Access Compliance Report

Public Rights-of-Way

Intersection ID: 17353	Main Street: JAMESTON_DR	Cross Street: LYNNWOOD_DR	Location: NW
ADA ID: B441B2F51641	Ramp Type: PerpDiag	Initial Pass/Fail: Fail	Overall Compliance: No
		Severity Score: 10

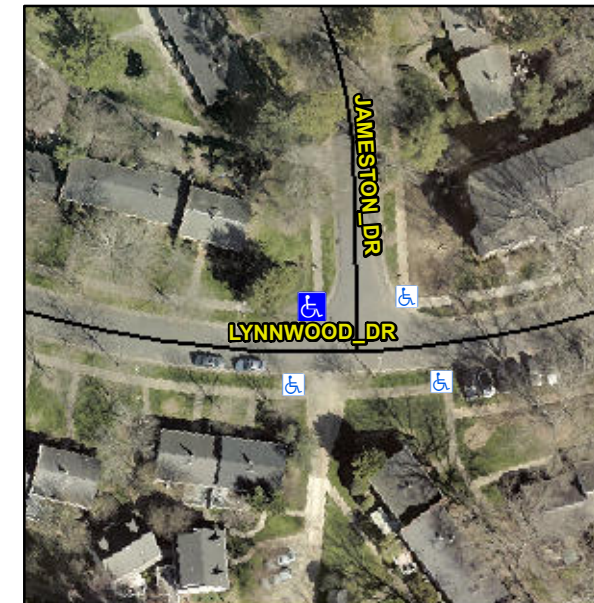
Not Found, R304.5.1, R304.5.3

Compliance	Description	Data	Compliance	Description	Data
N/A	Ramp Length (in)	62.0	Yes	Ramp Slope (%)	5.9
No	Ramp Width (in)	38.5	No	Ramp XSlope (%)	4.1
N/A	Flare Type LT	N/A	N/A	Flare Type RT	N/A
N/A	Flare Slope LT (%)	N/A	N/A	Flare Slope RT (%)	N/A
N/A	Flare Traversable LT?	N/A	N/A	Flare Traversable RT?	N/A
N/A	Landing Length (in)	N/A	N/A	DWS Provided?	N/A
N/A	Landing Width (in)	N/A	N/A	DWS Contrast?	N/A
N/A	Landing Slope (%)	N/A	N/A	DWS Length (in)	N/A
N/A	Landing X Slope (%)	N/A	N/A	DWS Full Width?	N/A
N/A	Landing Curb? (Y/N)	N/A	N/A	DWS Offset (in)	N/A
N/A	Shared Landing?	N/A			
N/A	Gutter Ponding?	N/A	N/A	Gutter Slope (%)	N/A
N/A	Gutter Lip Ht (in)	N/A	N/A	Gutter X Slope (%)	N/A
N/A	Painted X Walk1?	No	N/A	Painted X Walk2?	No
	X Walk 1 Direction	To SW		X Walk 2 Direction	To E
N/A	X Walk 1 Width (in)	N/A	N/A	X Walk 2 Width (in)	N/A
	X Walk 1 Slope (%)	1.6		X Walk 2 Slope (%)	7.0
	X Walk 1 X Slope (%)	0.9		X Walk 2 X Slope (%)	0.4

Remove & Replace Curb Ramp With Two New Directional Ramps or Equivalent.
